November 1, 2022

ADDENDUM 2

Walnut Valley Unified School District
Diamond Bar High School
Building 400 Modernization New Classrooms/Library Media
DSA #03-121330 | File #19-H52

SEALS:

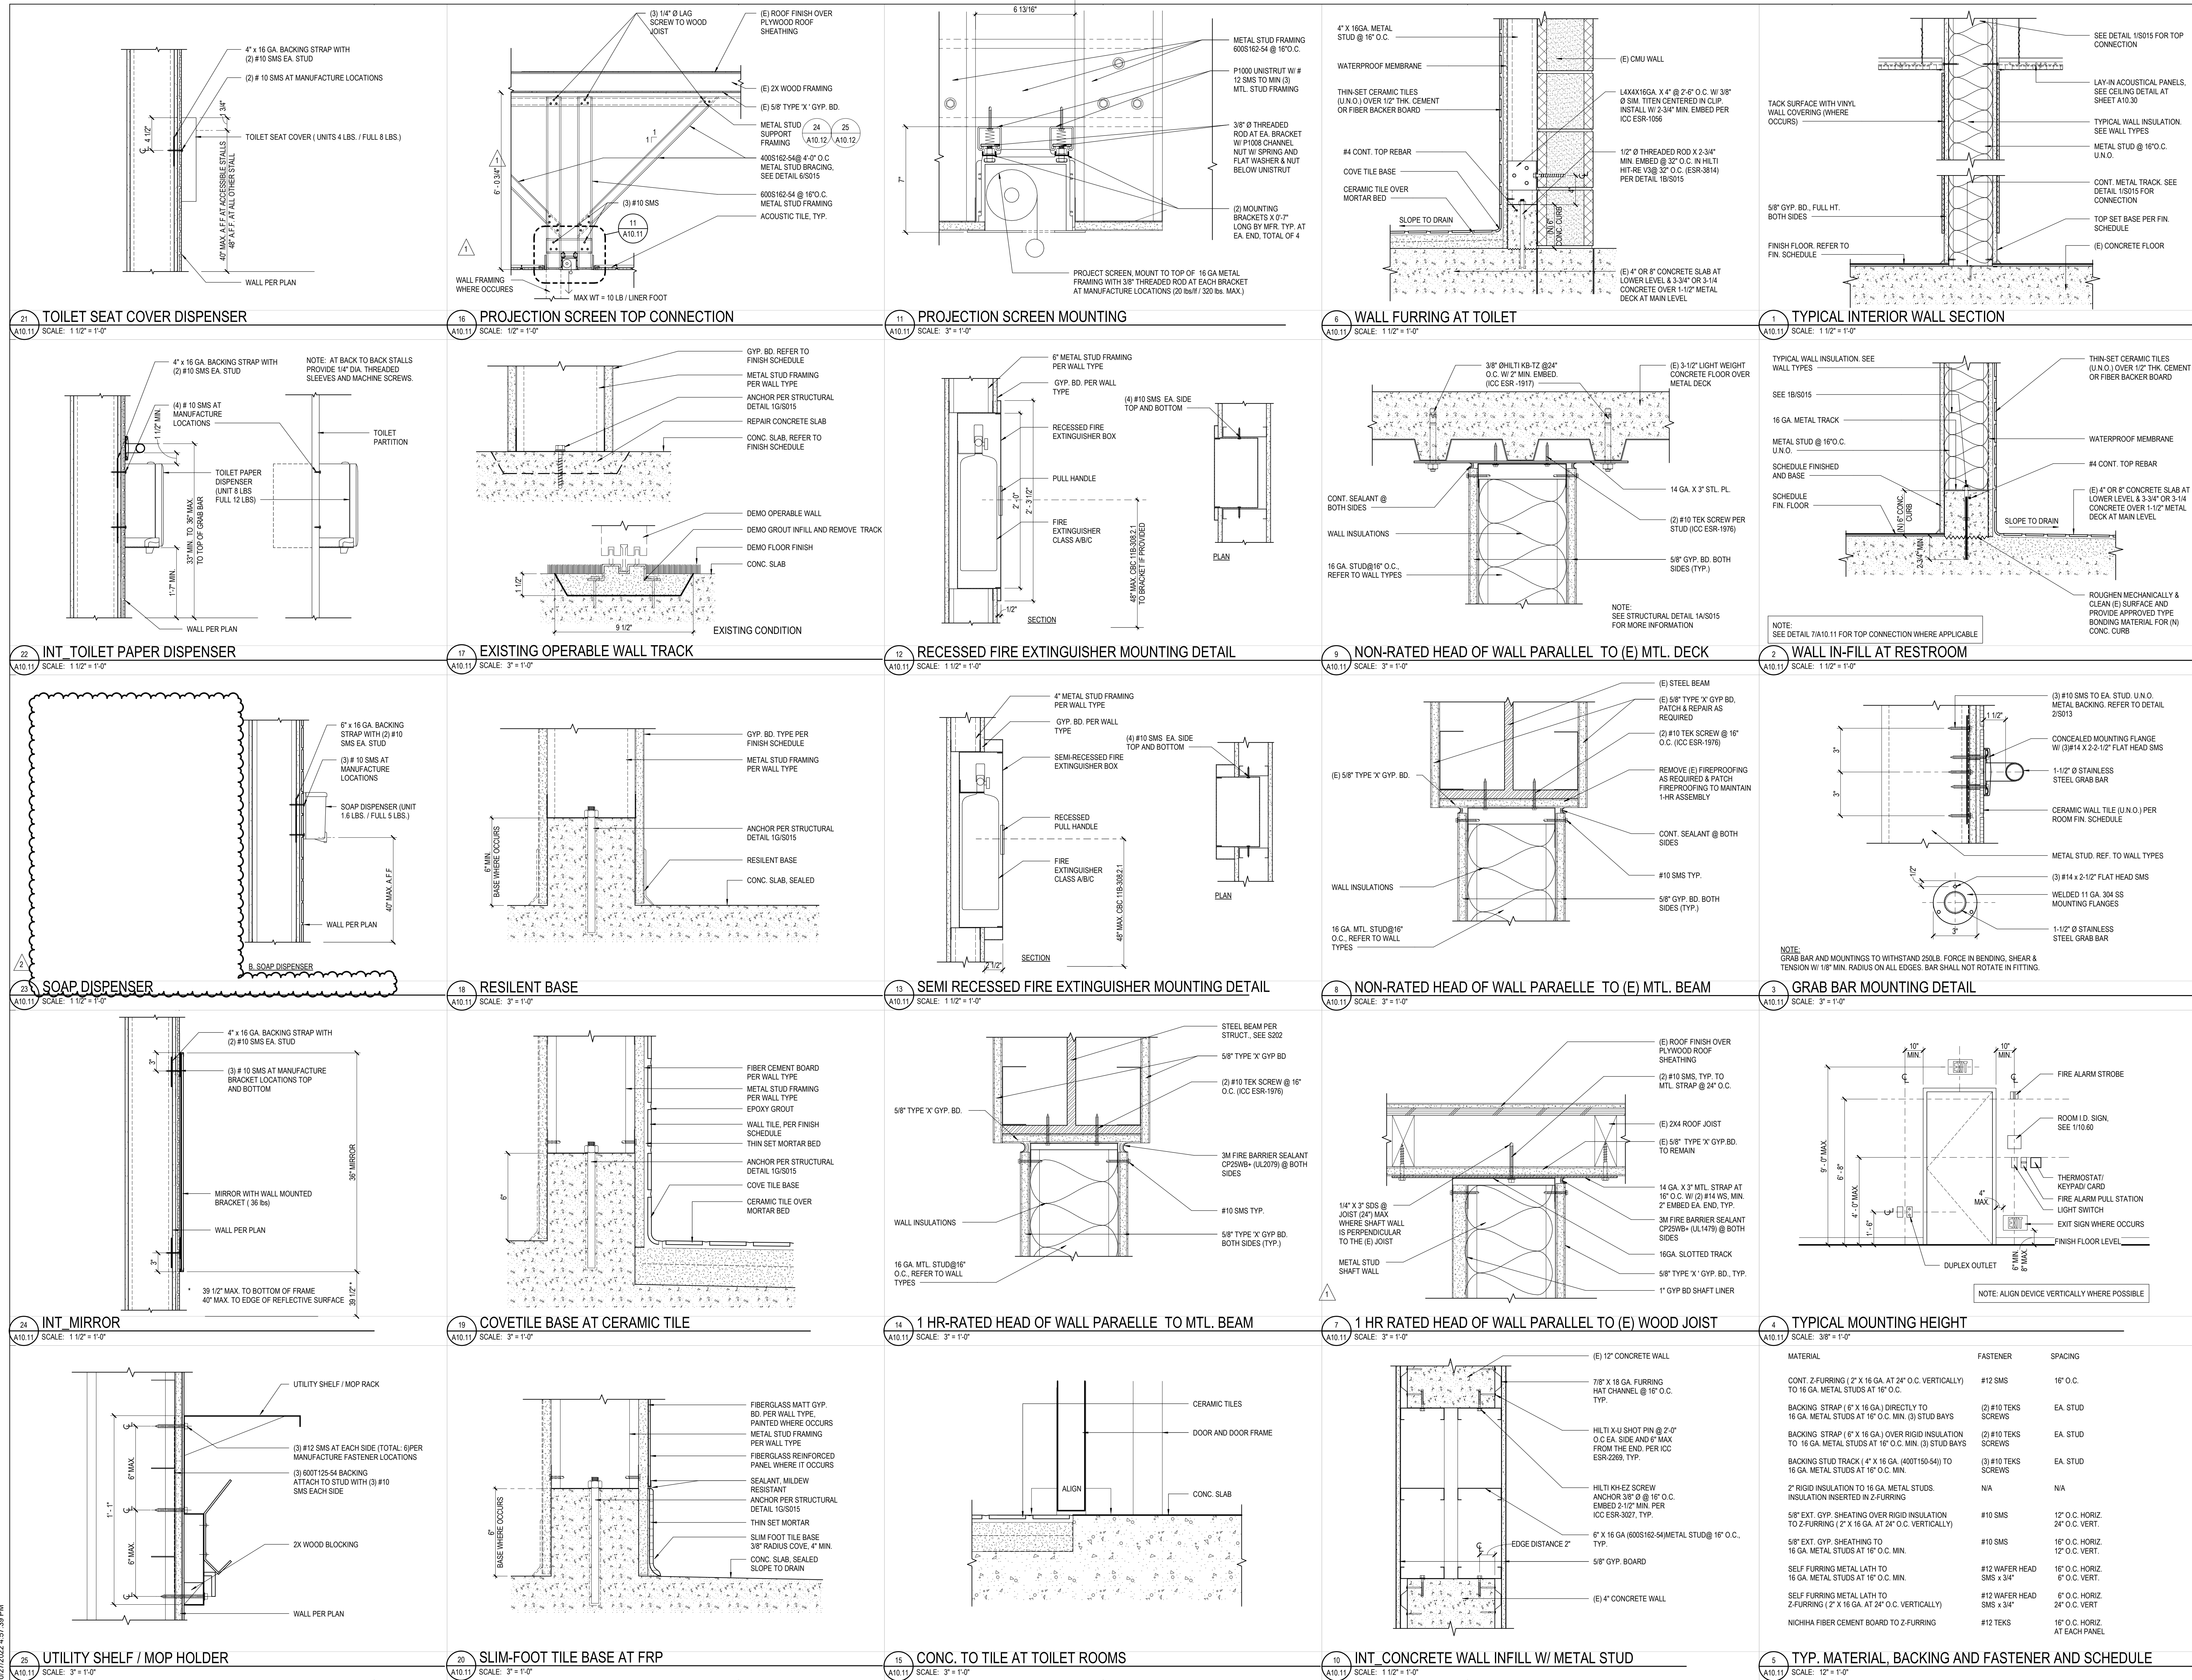
A2.01 DEMOLITION PLANS – LOWER LEVEL & MAIN LEVEL

- A. KEYNOTES: ADDED KEYNOTE 3.300
- B. 1/A2.01: ADDED AREAS FOR SLAB REMOVAL AND PATCH BACK TO INSTALL BELOW SLAB PLUMBING AND ELECTRICAL ITEMS

- DESCRIPTION
- 3.300 REMOVE PORTION OF (E) 8" CONCRETE SLAB ON GRADE FOR UNDER GRADE PLUMBING AND CONDUIT WORK. REPAIR AND PATCH WATER BARRIER AND CONCRETE. LOCATIONS SEE ELECTRICAL, PLUMBING AND MECHANICAL DRAWINGS.
